SERVICE BULLETIN

Can-Am® On-Road

Subject: **Repair Procedure Revision - Brake Light
Switch Adjustment**

2021-4

SPYDER RT

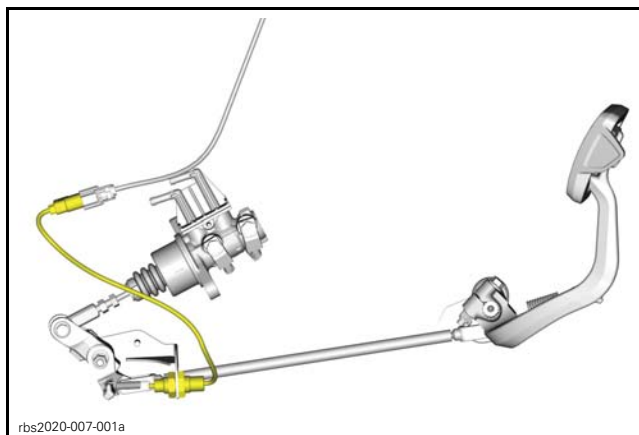
Vehicle may indicate brake light switch failure, rear brake light stays ON or flashes intermittently. One of the probable cause is the adjustment of the brake light switch / low pressure switch.

NOTE: The rear light should stay OFF when the brake pedal is released or with a small movement of less than 4 mm (5/32 in).

- **Task:** *INSPECTING THE ADJUSTMENT OF THE BRAKE LIGHT SWITCH / LOW PRESSURE SWITCH (BLS/LPS).*
- **Task:** *ADJUSTING THE BRAKE LIGHT SWITCH / LOW PRESSURE SWITCH (BLS/LPS).*
